LAND USE APPLICATION SUMMARY

Property Location: 2841 Hennepin Ave
Project Name: 2841 Hennepin Apartments
Prepared By: Mei-Ling Smith, Senior City Planner, (612) 673-5342
Applicant: Bryan Farquhar, Trilogy
Project Contact: Gretchen Camp, ESG Architecture & Design
Request: To construct a new seven-story, mixed-use building with 144 dwelling units and 2,800 sq. ft. of commercial space.

1 PHOTOMETRIC SITE PLAN
SCALE: 1" = 20'-0"

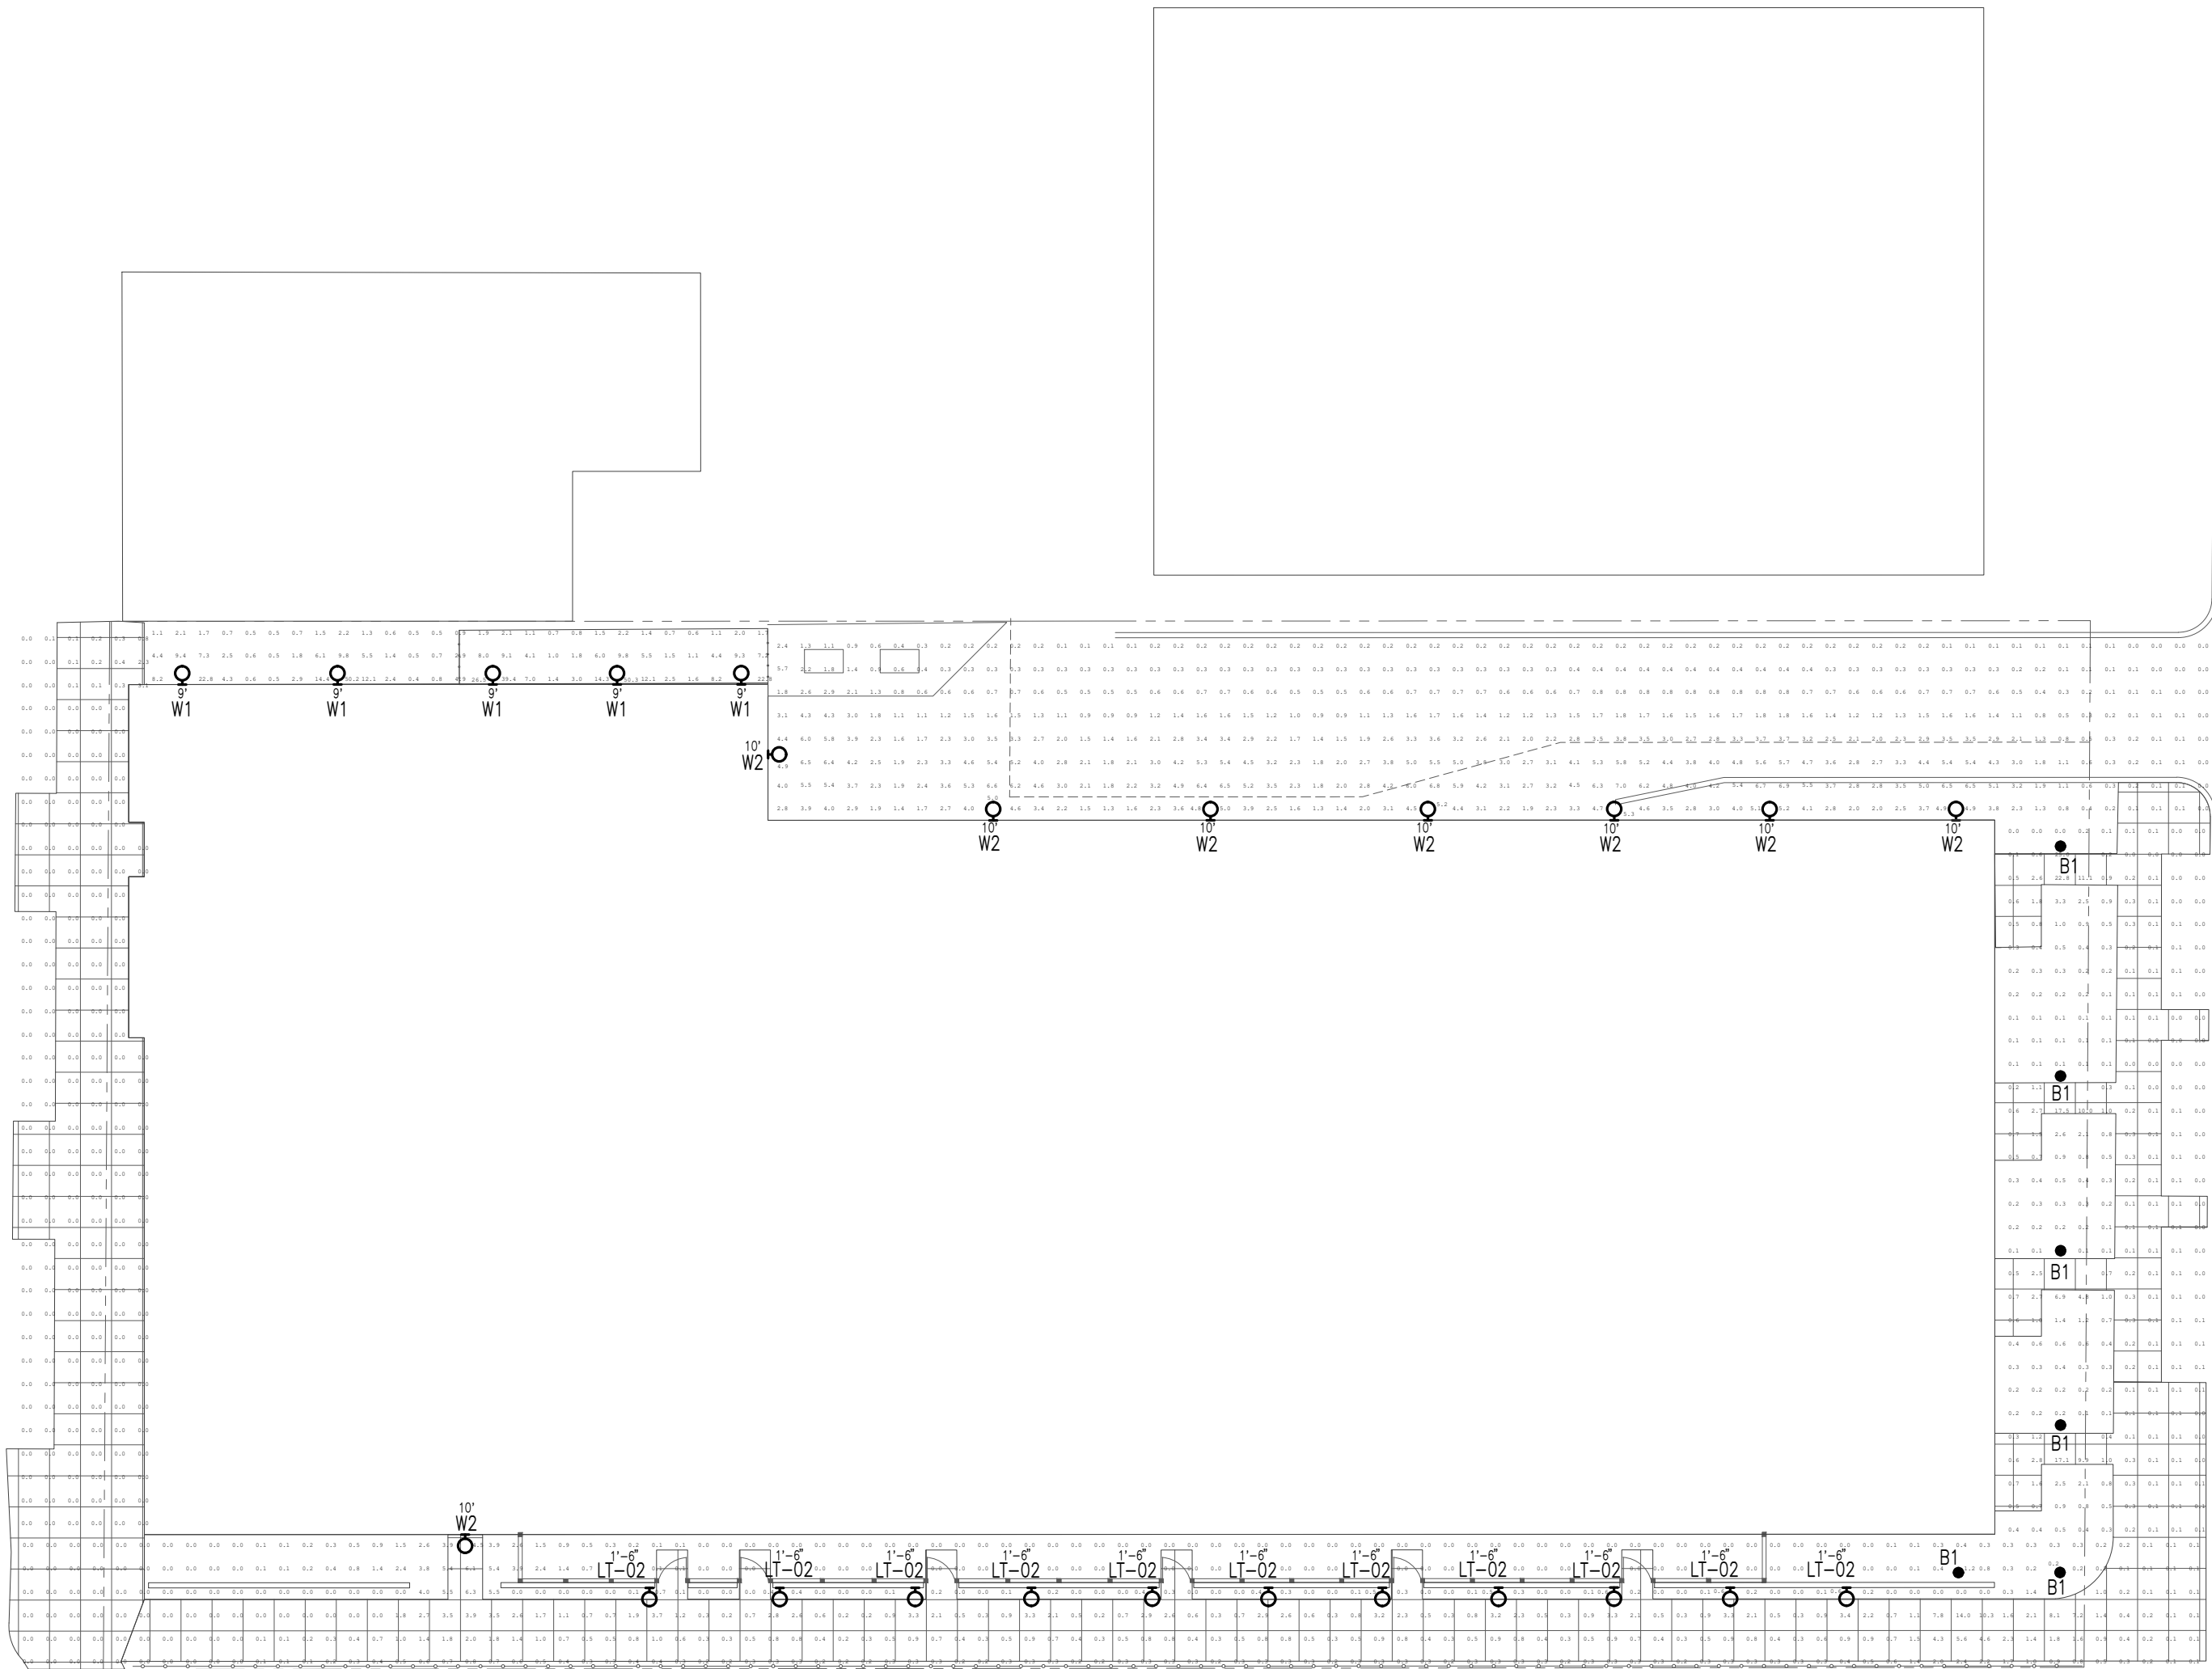
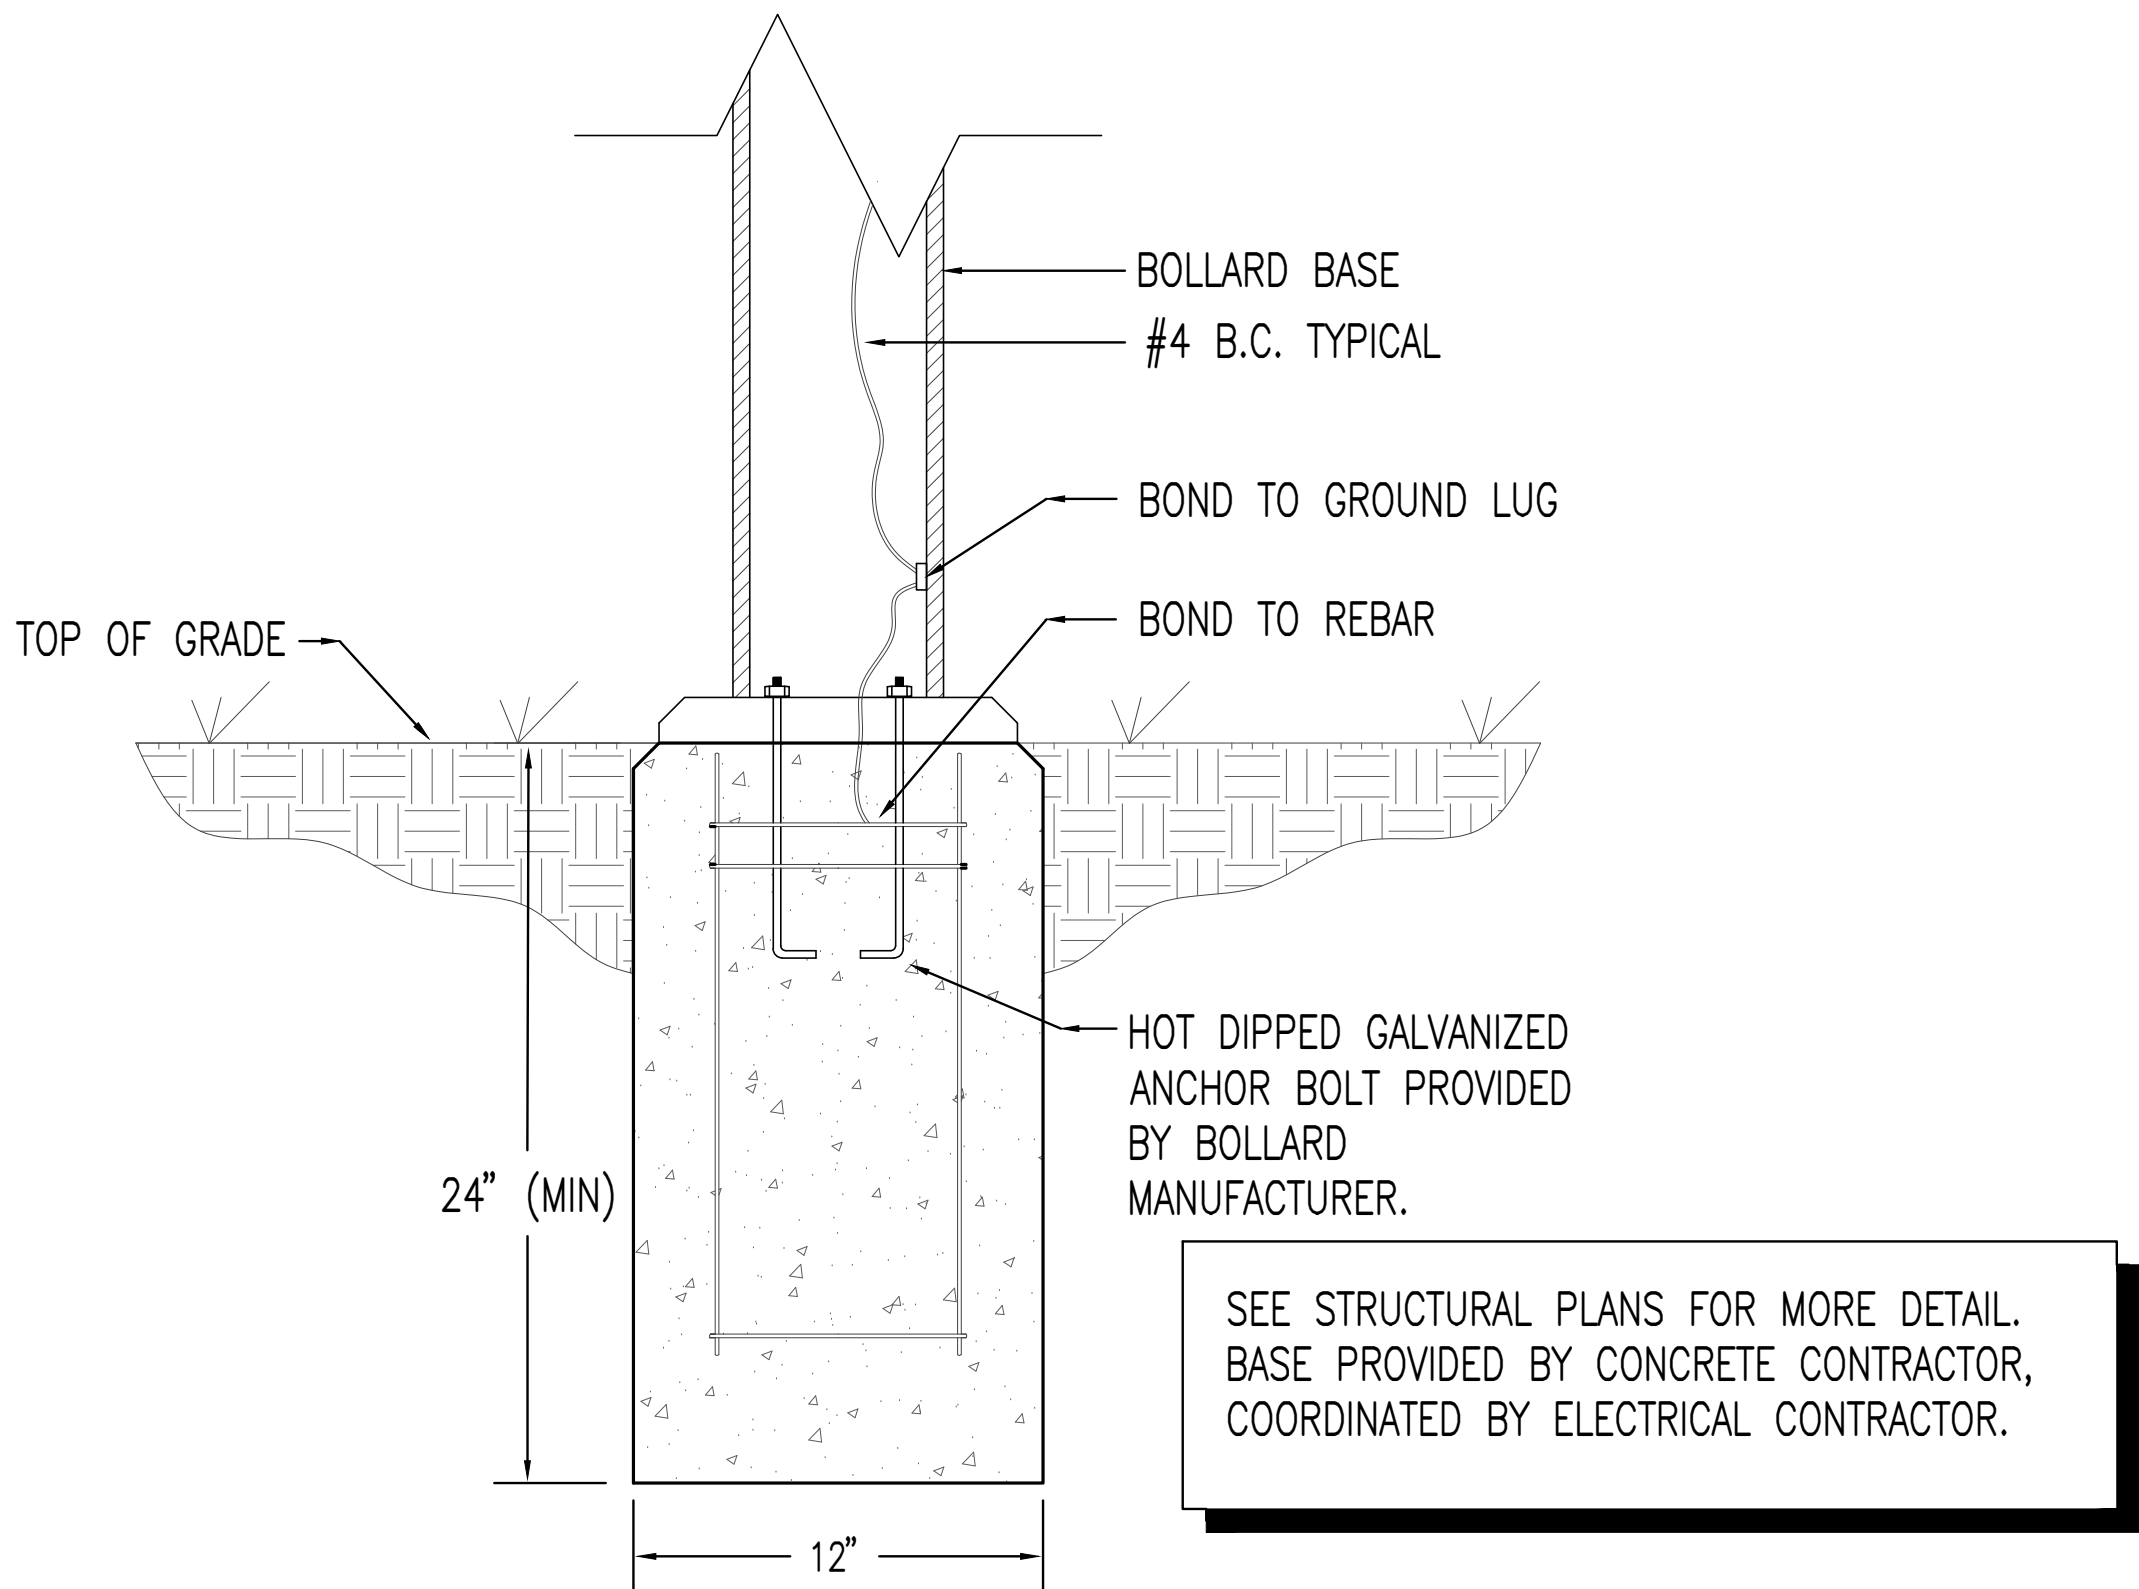
- The proposed project would comply with crime prevention through environmental design (CPTED) standards.
- The photometric plan submitted by the applicant does not show lights along the Hennepin Ave entrances. With the recommended conditions, the project would provide lighting on site, at all building entrances, and along walkways that maintains a minimum acceptable level of security while not creating glare or excessive lighting of the site.

5. Buildings shall contain pedestrian scaled exterior lighting on all street-facing elevations. Said lighting shall be mounted on the first story, evenly spaced and directed in a manner that illuminates the ground plane. Lighting shall be provided at all building entrances and along walkways that maintains a minimum acceptable level of security while not creating glare or excessive lighting of the site.
